Board Agenda Item #:	IV A – Action Item
Date:	February 13, 2020
To:	Magnolia Educational & Research Foundation dba Magnolia Public Schools (“ <b>MPS</b> ”) Board of Directors (the “ <b>Board</b> ”)
From:	Alfredo Rubalcava, CEO & Superintendent
Staff Lead:	Patrick Ontiveros, General Counsel & Director of Facilities
RE:	Recommendation of Ad Hoc Committee to Board to Approve MSA-1 Change Order Requests

The Ad Hoc Committee recommends and moves that the MPS Board approve change order requests 37 to 54 up to \$176,614.96 as presented by Oltmans Construction Co. (“**Oltmans**”) for the new construction project for the benefit of MSA-1 at 18220 Sherman Way (the “**Project**”) with the payment amount to be confirmed by MPS Staff based on a review of all change order requests and back-up.

Oltmans Change Order Requests

**ROOF CONSTRUCTION PLAN**  
SCALE: 1/8" = 1'-0"

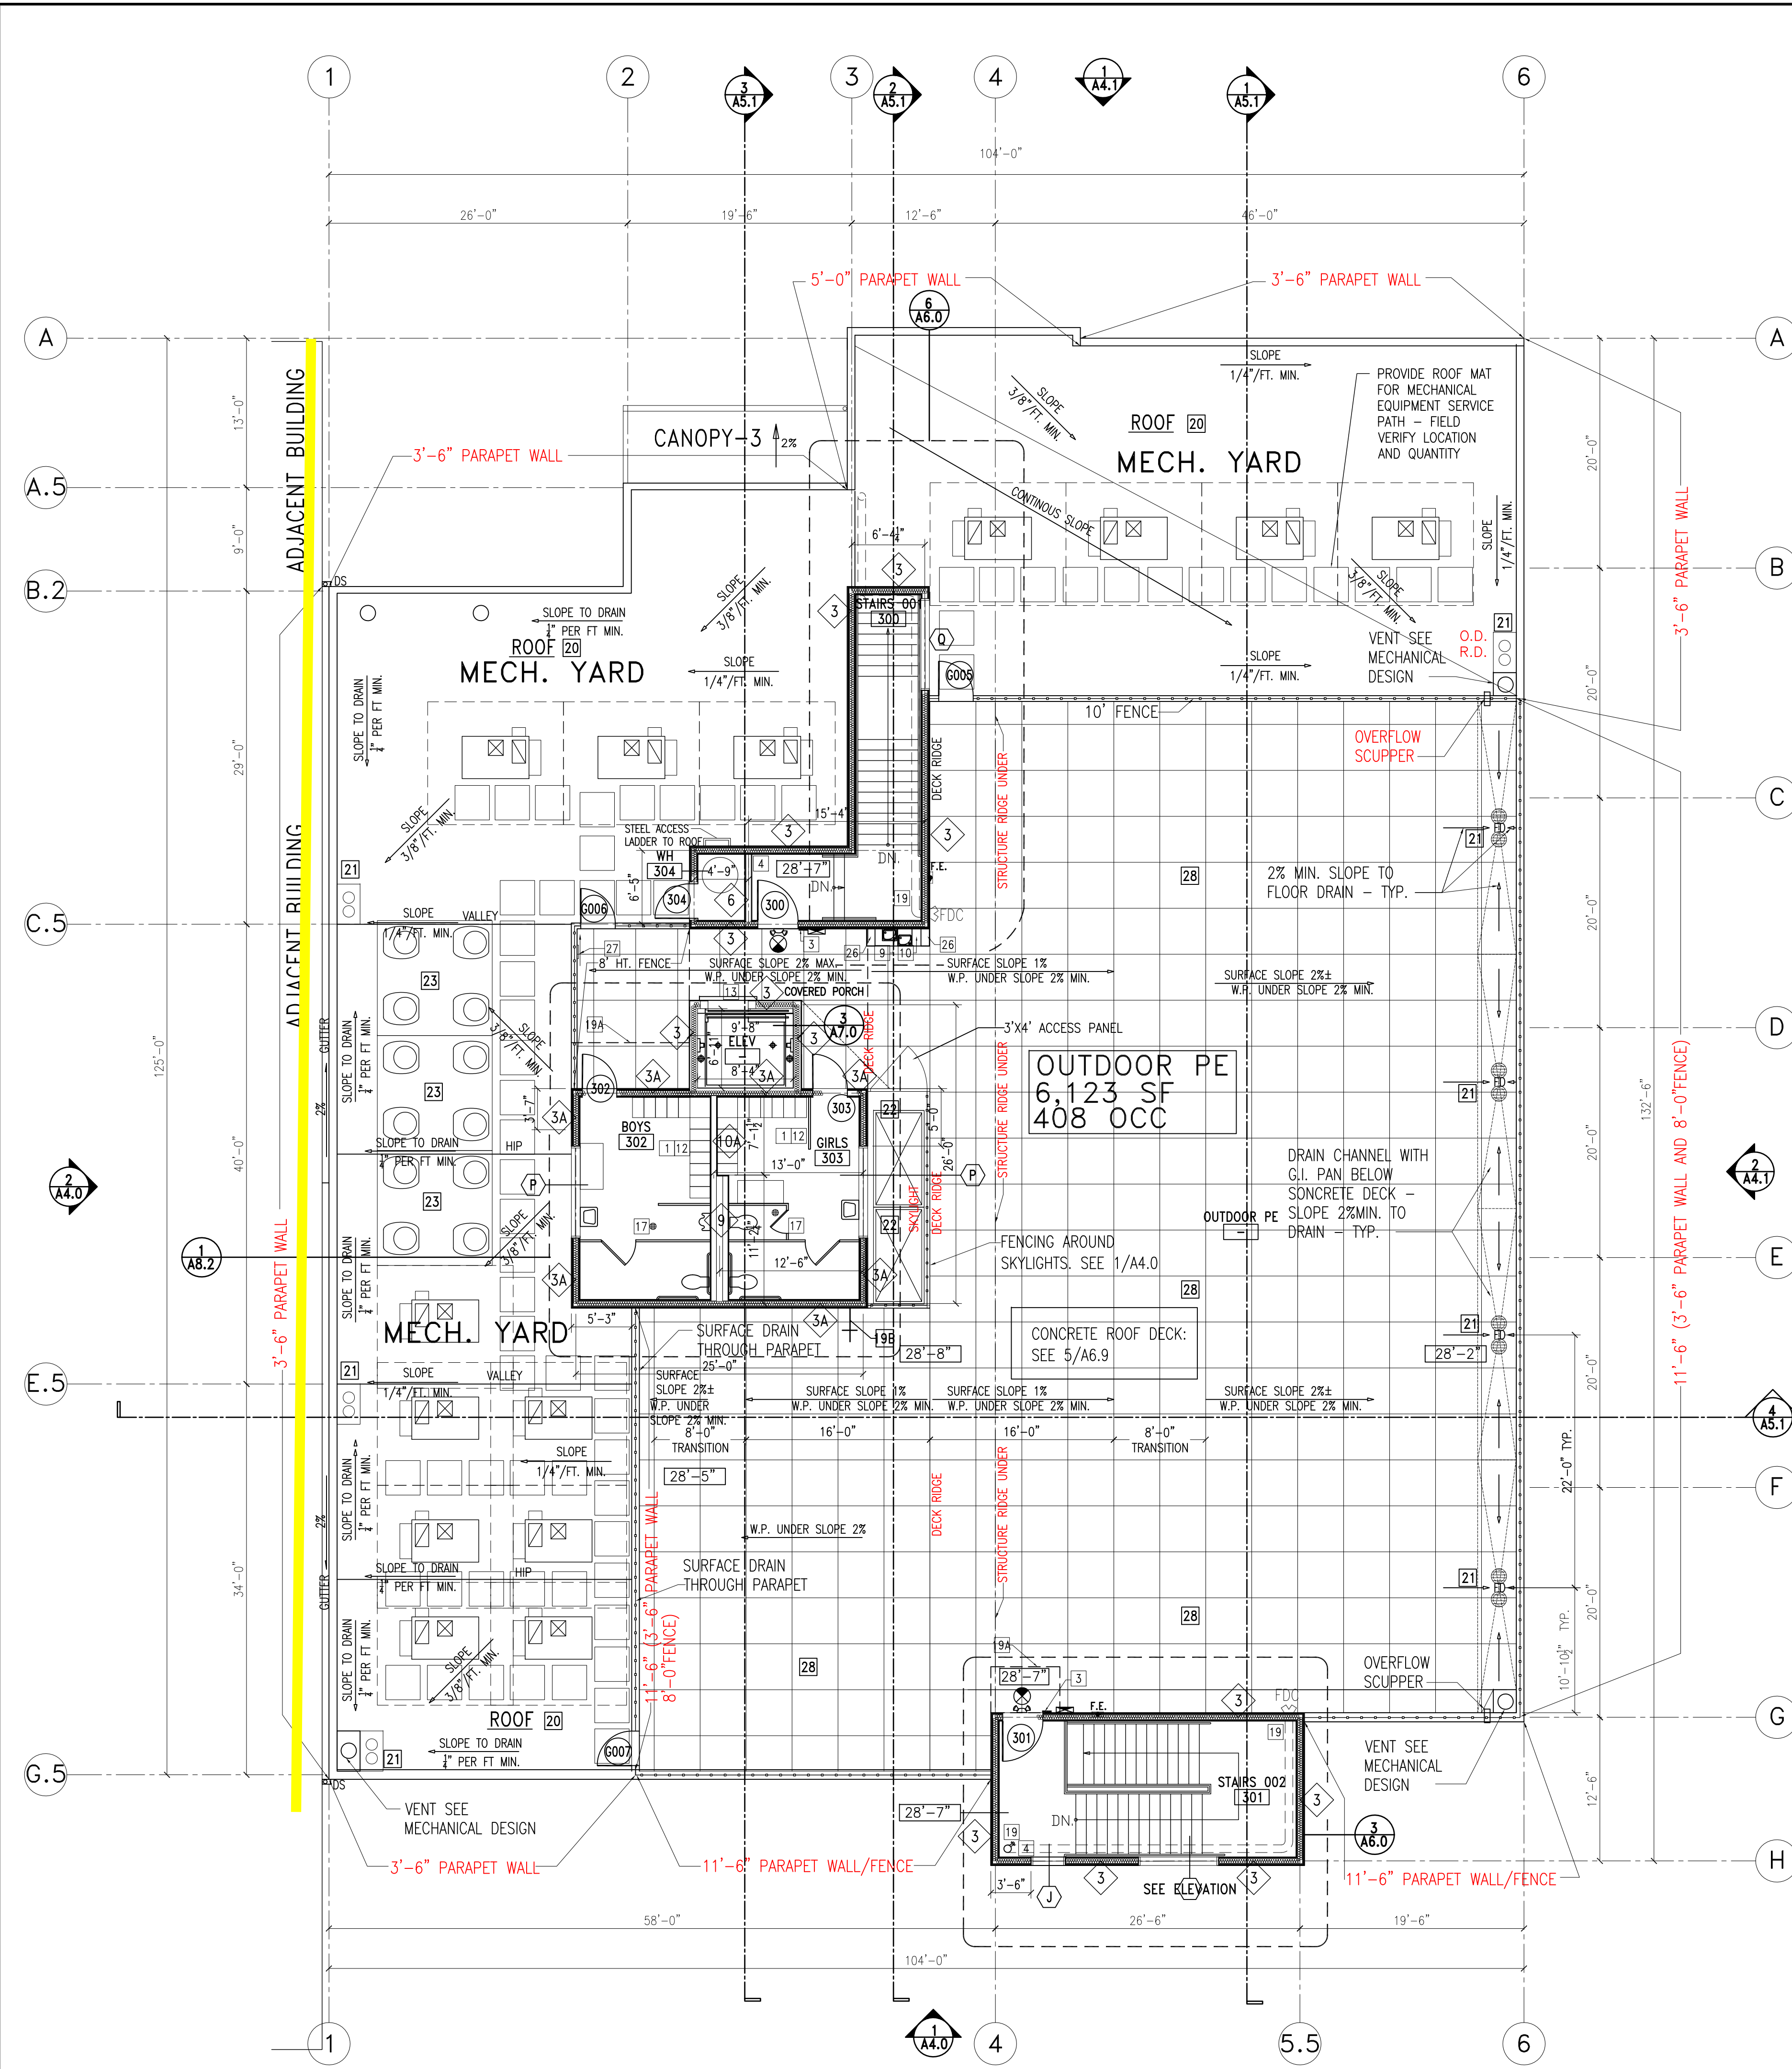
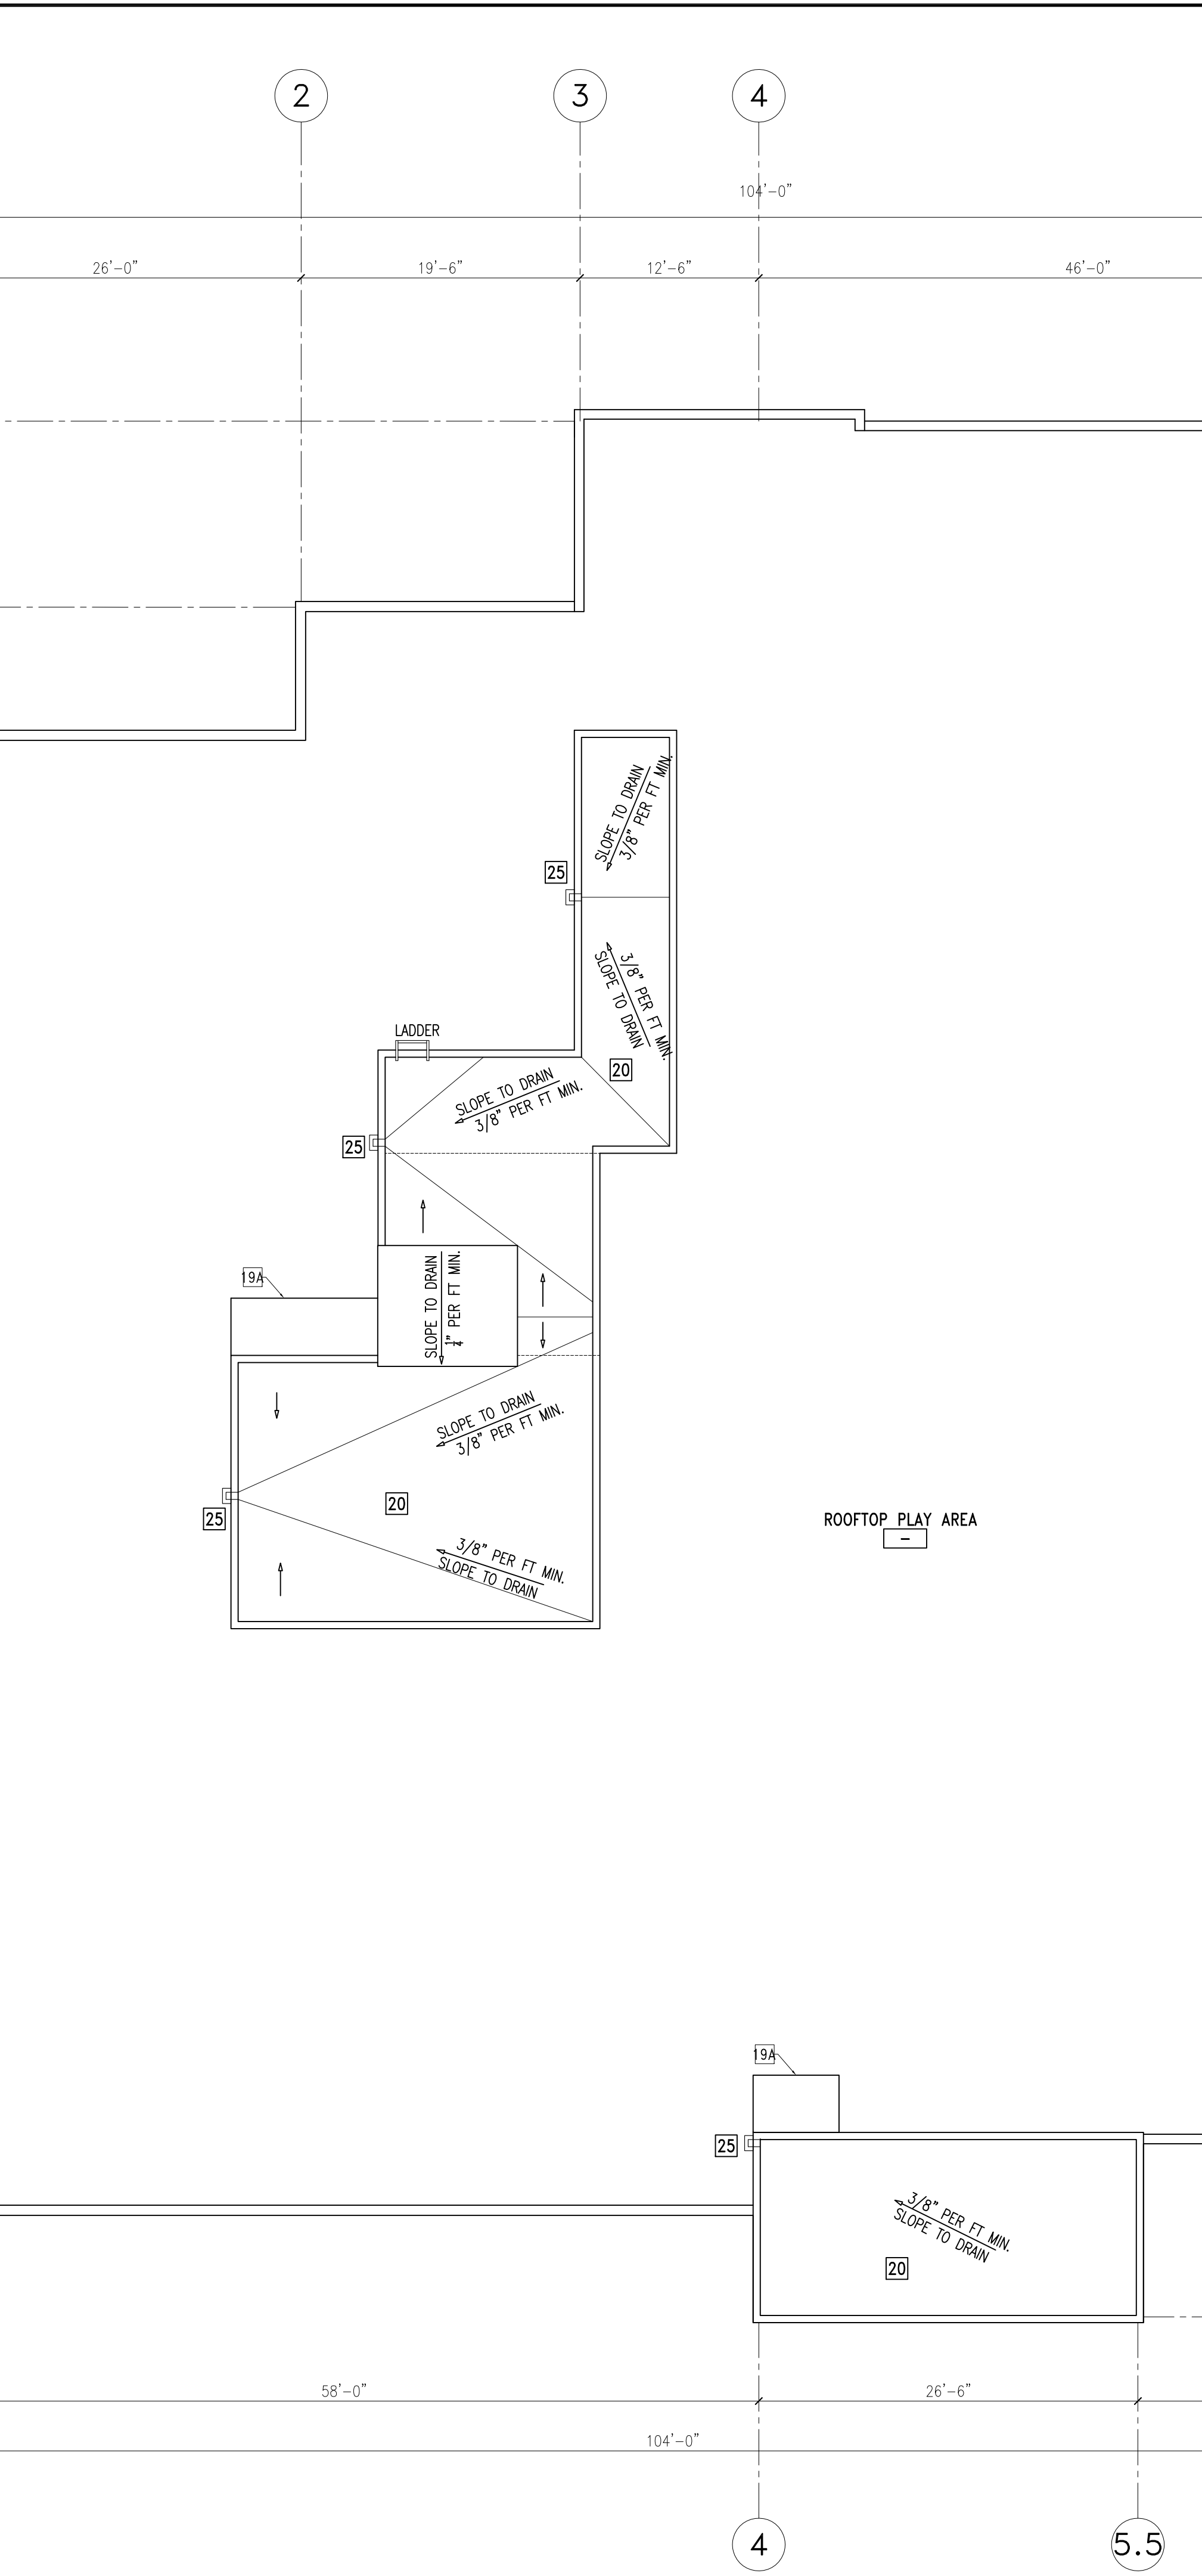
- Building to building flashing @ G/L 1 PP A3.1 as per bulletin 1&2 in lieu of gutter
- Credit for Gutter - @ G/L 1 PP A3.1

see attached highlighted plan.
